# <u>Deficiency Progress Report - Update 7</u>

Report Submitted: 7-21-08

**CUPA Name:** Los Angeles City Fire Department

**Table 1, Envision UDF Table**

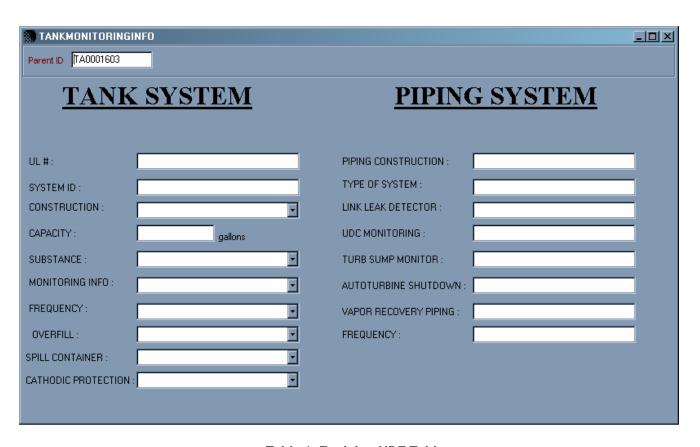
Cal/EPA's 5<sup>th</sup> Response: Refer to SWRCB comments. Cal/EPA recommends that the CUPA include the newly approved monitoring plan form (Form D) with the permit to operate for each UST facility. The new form contains all of the monitoring requirements that need to be included with the permit. This option or the others mentioned below by the SWRCB would be acceptable to correct this deficiency. Cal/EPA accepts that any option chosen by the CUPA is only temporary until the Envision Connect database is fully able to populate the monitoring information directly onto the facility permits.

SWRCB's comments: All of the monitoring information that should be on the operating permit is contained in the A, B & D forms submitted by the UST owner/operator. The UST owner should NOT have to fill out additional forms as suggested, as it is duplicative information. Since the new form D (Monitoring Plan) is now in regulation, LA City could make a copy of the approved monitoring plan and provide it to the permittee instead of putting the information on the permit itself, although, it would be a larger permit package.

Alternately, the permit could be printed using a report from Envision (or Envision Connect) using all of the information needed. The data elements in Envision should be (or soon will be) the same as contained on the new forms. Of course, the permit would need to be a report

developed by Envision, unless the user can develop reports of their own.

A third option would be for the CUPA to have a permit template and type in the information needed for each permit. This is time consuming, but, would get the job done.

If using Envision Connect is the preferred method for correcting this deficiency, LA City Fire should provide a copy of a permit showing all of the required elements to CalEPA and SWRCB.

Note: Include "pipe monitoring" on the permit... this was inadvertently left off the sample permit provided.

At this time the Los Angeles Fire Department CUPA respectfully requests for this deficiency to be rescinded and be amended with the use of the newly approved monitoring plan form (Form D). The Fire Department does not believe there is a need to modify the current permit to included a table listing the UST and pipe monitoring options, since this information will be available on the newly approved Form D. In addition our current permit already has a statement that requires the owner/operator to have an approved monitoring plan, emergency response plan and a site map detailing the required information.

All the required monitoring information is contained on Forms A, B, and D and a copy of these forms are required to be maintained at each UST facility. The UST owner/operator should have readily available for review the newly approved Form D at the site along with the approved emergency response plan and a site map. To avoid the duplication of the information found in Form D, the Los Angeles Fire Department respectfully requests that Form D be use in lieu of the UDF Table.

- SWRCB's Response: The SWRCB will not rescind the deficiency, and has no plans to amend the regulations to remove the provision, however, the SWRCB will consider the deficiency corrected upon the following:
  - 1. The UST tank numbers, as assigned by the CUPA, are listed on the permit, or on an attached Form B.
  - 2. The monitoring plans (Form D) are reviewed and approved by the CUPA and attached to the Consolidated Permit as part of the permit. The CUPA shall maintain a copy of the approved plan in their files.

**CUPA's 7<sup>th</sup> Status Update (7-21-08):** The Los Angeles Fire Department (LAFD) will implement Cal/EPA's and SWRCB's recommendation and use the newly approved monitoring plan (**Form D**) to amend and fix LAFD's deficiency 4.
